## Addendum #1

**Brewer Armory Telecom (IT) Room Repair Project - Project No: 23SR19-310-D4, Bid Number #23-029**

Directorate of Facilities Engineering

28 August 2023

SHEET ID:  
**M-501**  
 SHEET: 14 of 18

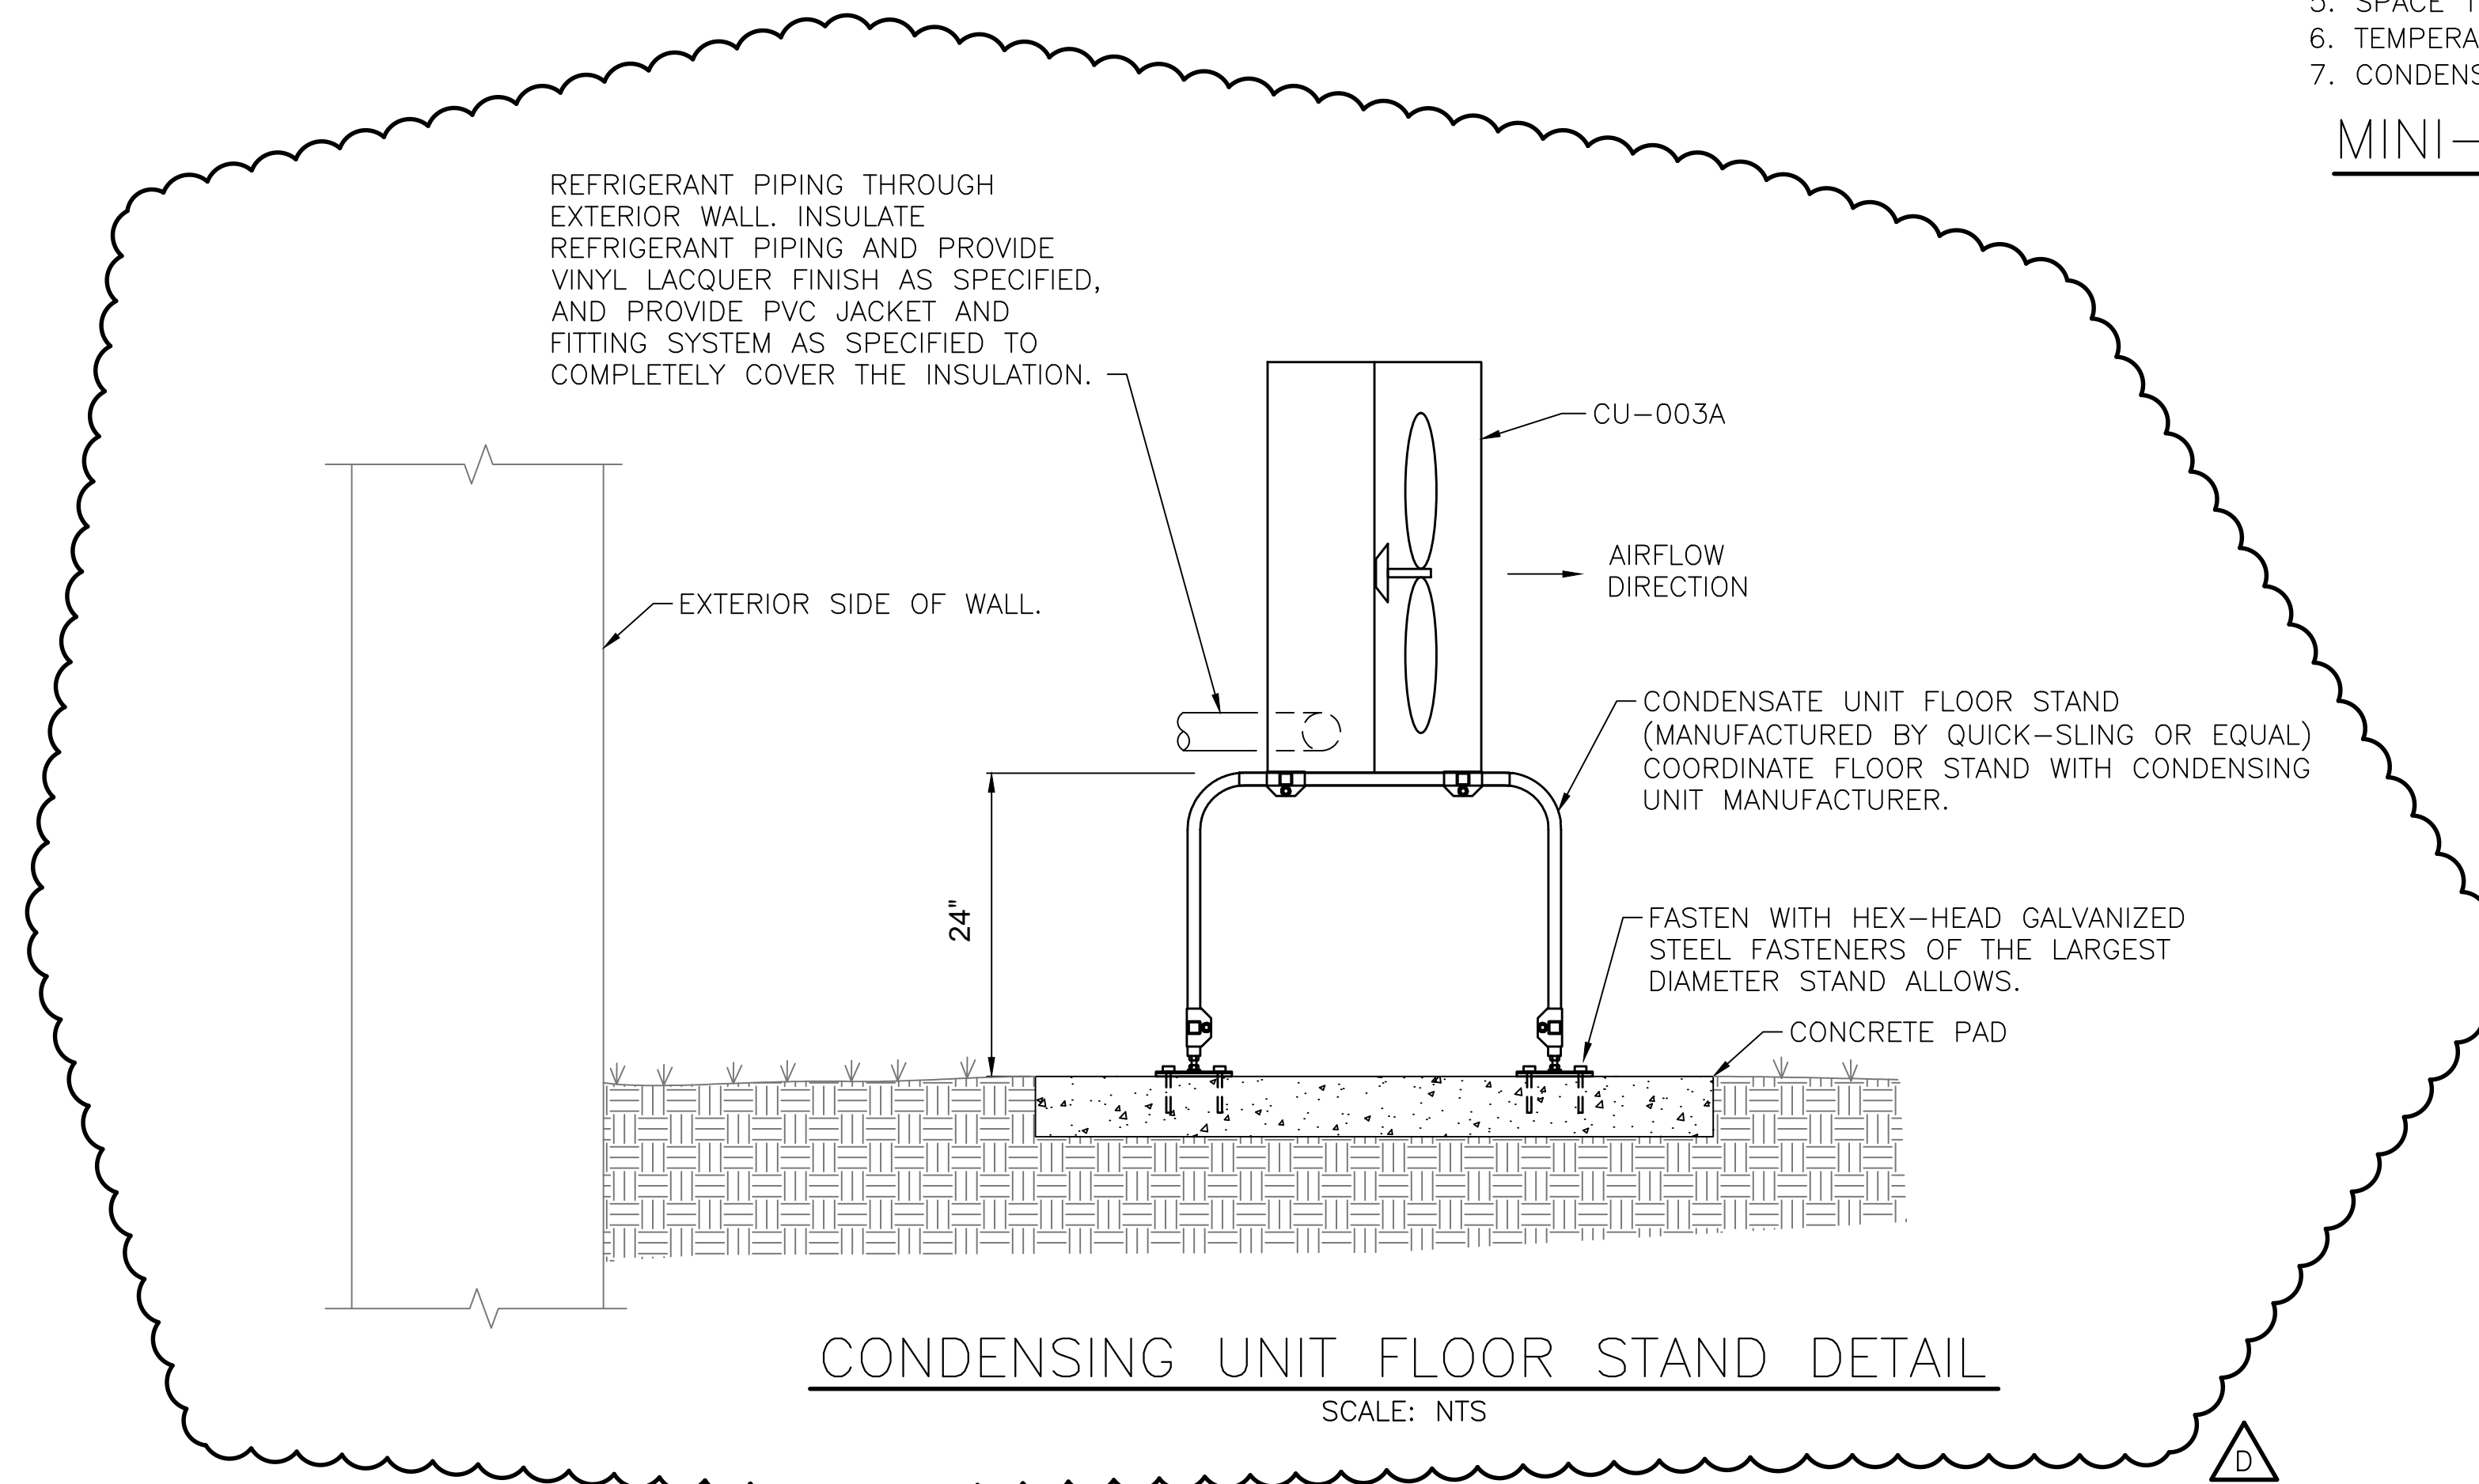
1. **Remove** Sheets C-101, M101 and M-501 and **Insert** attached Sheets C-101, M101 and M-501. All changes regard either the attachment of the mini-split condensate unit to the facility or its placement on a concrete pad immediately adjacent to the facility (ABI#1)

A: TBD. MEARNG has reached out to the Historical Society for a determination. Design drawings have been revised to show painting of the unit to match the brick façade if the unit is allowed to be mounted on the wall.

**CONDENSING UNIT WALL BRACKET DETAIL**  
SCALE: NTS

**CONDENSING UNIT FLOOR STAND DETAIL**  
SCALE: NTS
